Subject: Re: [Application No. A/NE-STK/32] – Comments from the Leisure and Cultural Services Department

Proposed Temporary Holiday Camp, Place of Recreation, Sports or
Culture (Hobby Farm), Field Study/Education/Visitor Centre, and
Public Vehicle Park (excluding Container Vehicle) for a period of 3 years
in “Village Type Development”, “Recreation (1)”, and the areas are
shown as ‘Road’ of various Lots in D.D 41 and the adjoining
Government Land, Sha Tau Kok, New Territories.

Further Comments from the New Territories North Tree Team LCSD:

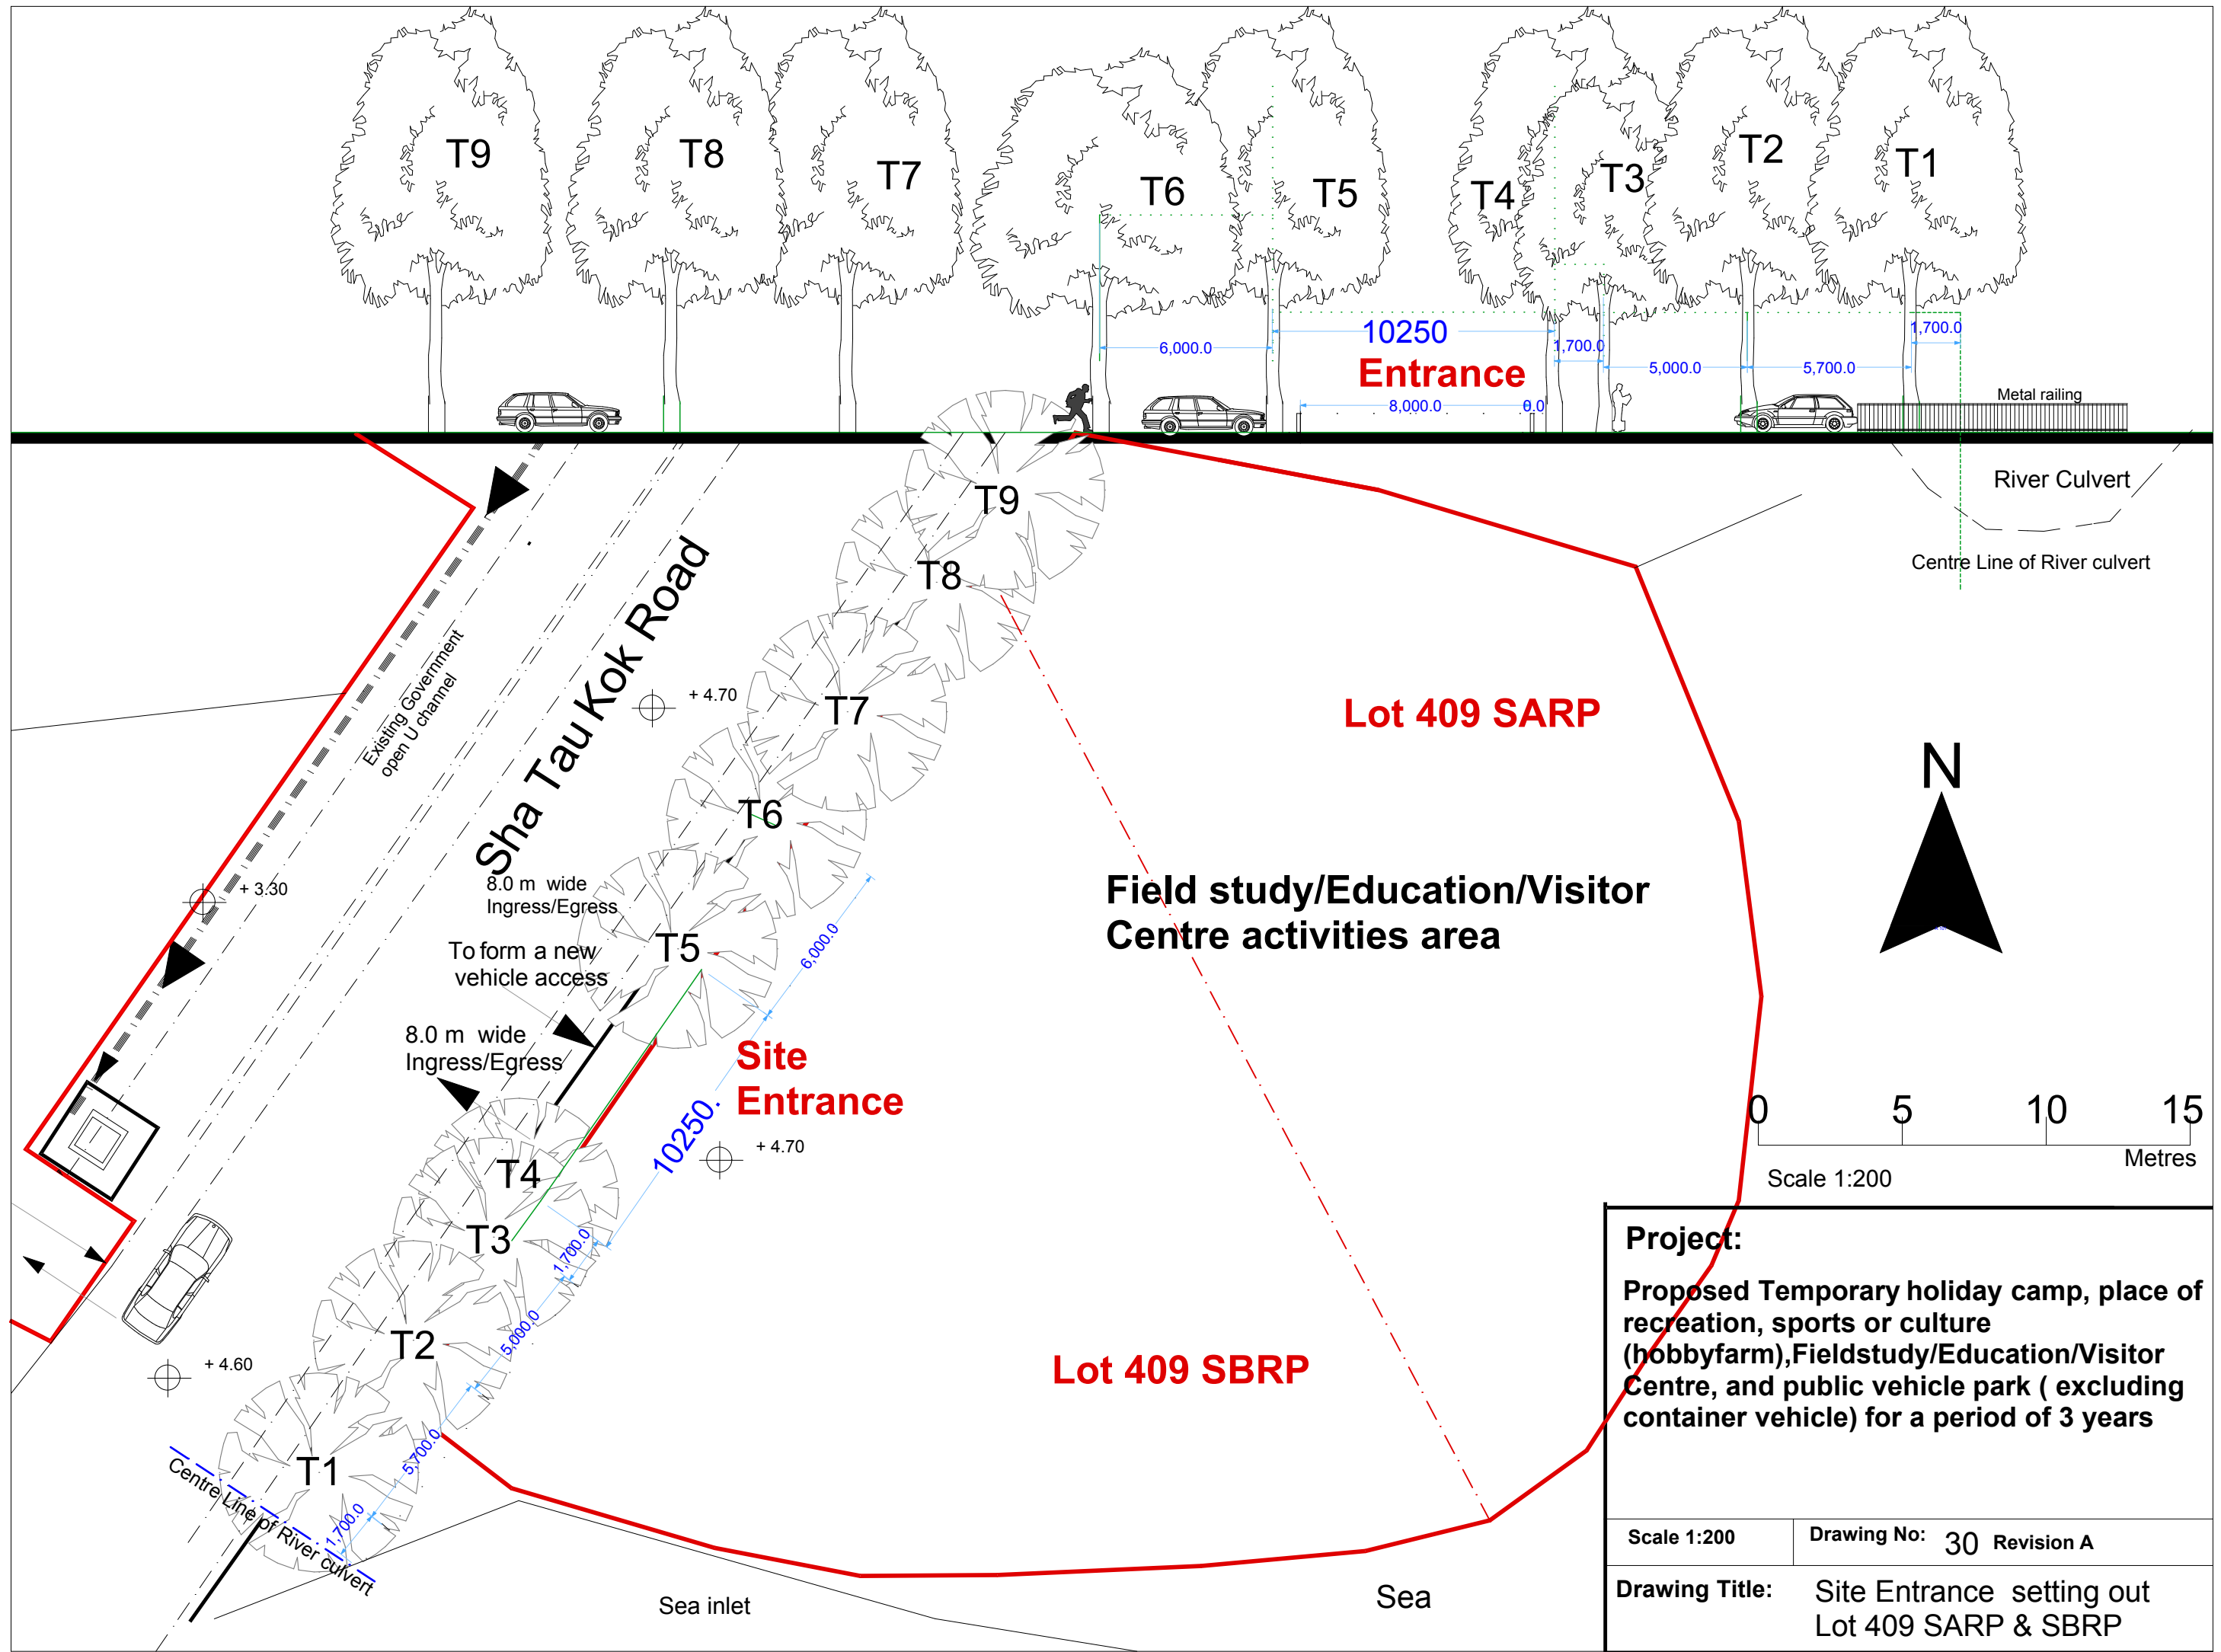
1. The applicant is requested to submit further information to indicate:
 - distance from the proposed Structure to the drip line of tree crown;
 - distance from the proposed structure to the tree trunk; and
 - distance from the run in / out to the tree trunks of T4 & T5.

2. According to the requirement of Transport Planning and Design Manual (TPDM) Volume 2, sufficient distance should be kept from the run in / out to the existing trees to avoid blocking of driving sight line (see **Photo** attached).
3. Meanwhile, the applicant should observe the "Guidelines on Tree Preservation during Development" of DEVB for the necessary requirement on tree protection (see **Attachment**).
[See attachment "Guidelines_on_Tree_Preservation_during_Development_e.pdf"]

I have reviewed our survey data for the Application Site and revised the Site Entrance Setting Out. The distance from the run in/run out to the tree trunks of T4 & T5, centre to centre of the tree trunks, is approximately 10,250 mm.

(Please refer to the Revised Site Entrance Setting Out drawing submitted herewith).

The average tree trunk size of those trees alongside the Application Site of Sha Tau Kok Road is 460mm in diameter, while the average drip line of the tree crown is approximately 5200 mm.

The width of the proposed site entrance is 8000 mm; there will be a gap of approximately 900 mm away from the tree on both sides.

The distance from the proposed single-storey structures to the tree trunk will be approximately 5600 mm.

The distance from the proposed single-storey structures to the drip line of the tree crown will be approximately 3000 mm.
